Work Order ID 105323

Item Name: Aft Crosstube - High

DART AEROSPACE LTD		Work Order: 105323
Description: Crosstube High Aft (412)		Part Number: D412-664-203
Inspection Dwg: D412-664-243 Rev: E		Page 1 of 1

DRAWING NO. D412-664-243	TITLE CROSSTUBE ASS'Y (412 HI AFT)	REV. E	DART AEROSPACE LTD ENGINEERING ORDER		D.E.O. NO. D412-664-243-E-2	SHEET NO. SHEET 1 OF 1	SCALE NTS
DRAWN <i>MP</i>	CHECKED <i>ASS</i>	MFG. APPR. <i>EE</i>	APPROVED <i>MP</i>		DE APPR. <i>MP</i>		
DATE 11.09.07	DATE 11.09.19	DATE 11.09.19	DATE 11.09.19		DATE 11.09.19

D412-664-603
BENT TUBE

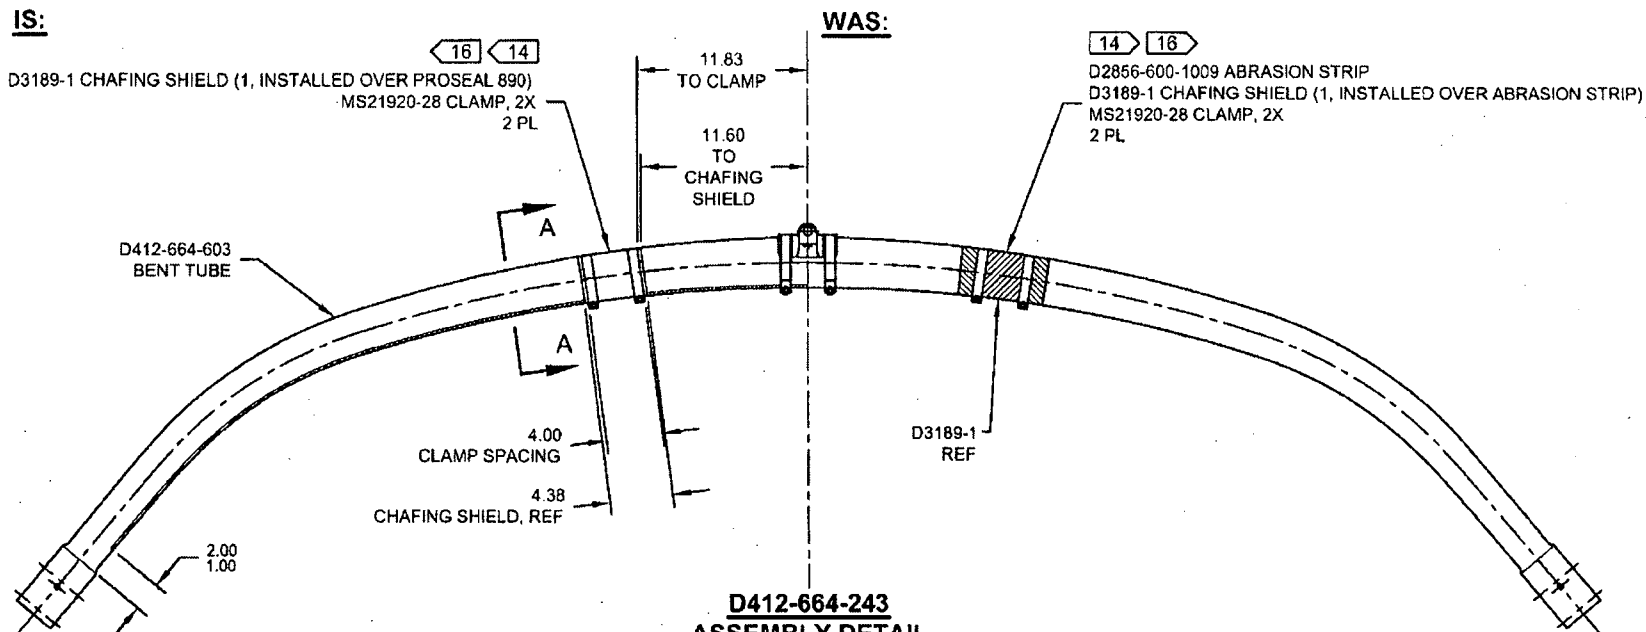
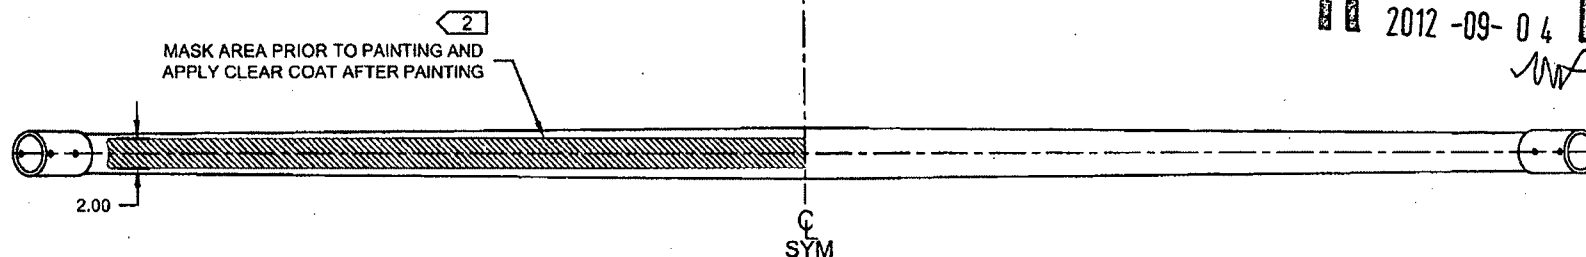
NOTES 2, 14, AND 16 ON SHEET 1 ARE AMENDED AS FOLLOWS:

IS:

D3189-1 CHAFING SHIELD (1, INSTALLED OVER PROSEAL 890)
MS21920-28 CLAMP, 2X
2 PL

WAS:

D2856-600-1009 ABRASION STRIP
D3189-1 CHAFING SHIELD (1, INSTALLED OVER ABRASION STRIP)
MS21920-28 CLAMP, 2X
2 PL
